**NOTICE OF SWIMMING POOL NON-COMPLIANCE**  
(Clause 22E, Swimming Pools Act 1992)

**Premises to which this notice relates:** 5 Riverhill Avenue Forestville.

**Pool Installation Description:** In-ground concrete swimming pool

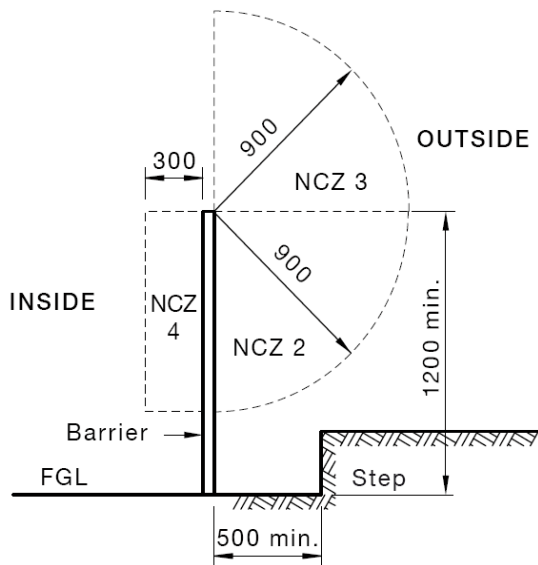
There was a gap greater than 100 mm between the boundary fence and the internal pool fence where the two fences intersected.

Reduce the gap to less than 100 mm using permanent and secure construction.

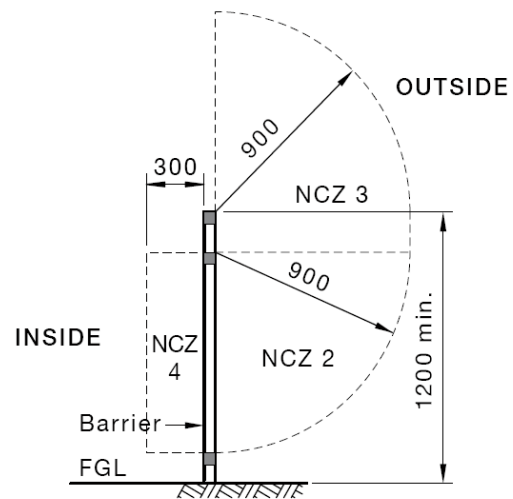
A Climbable mesh, a fence rail and brick ledge were located on the outside of the internal pool fence that were within the 900 mm Non-Climb Zone (NCZ 2 & 3) and the 300mm inside of the barrier. The 900 mm NCZ is required to be kept clear so that children cannot use any object close to the fence to assist them to climb into the pool enclosure.

Remove or relocate or shield the climbable objects within the 900 mm NCZ. The NCZ is a 900 mm arc measured from the top of the fence and extends upward above the fence (ie the 900 mm NCZ is semi-circular in shape) The 300mm NCZ is on the inside of the barrier. See diagram below

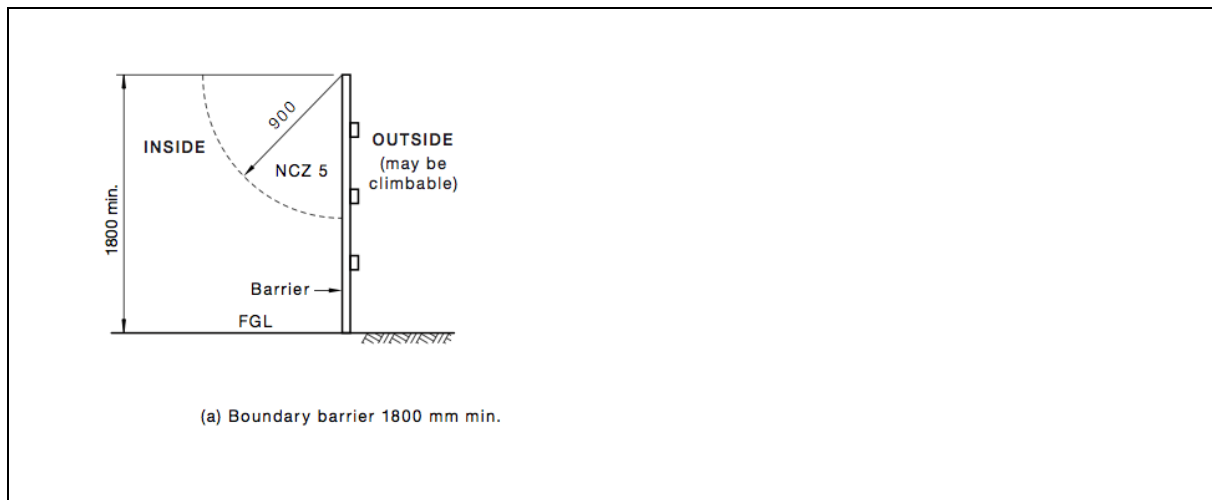
Sections of the boundary fence were less than 1800mm high. Boundary fences must be a minimum of 1800mm high measured poolside.

A boundary fence also has a Non Climb Zone at the top of the fence. There was vegetation and components of the boundary (rails and non compliant lattice) that could be used to assist children climbing down into the pool enclosure.

Replace or raise boundary fences so they are 1800mm or more.

Boundary fences must be provided with a 900 mm Non-Climb Zone (NCZ 5) which is located at the top of the fence (on the pool side of the fence). The boundary fence must be provided with a 900 mm NCZ 5 and any fence extension construction provided on top of the existing fence or rails etc (that have footholds greater than 10 mm wide) must not be within the 900 mm NCZ 5. Any climbable fence component within the 900 mm NCZ 5 will need to be either lowered, removed or shielded to ensure that children cannot use any climbable fence
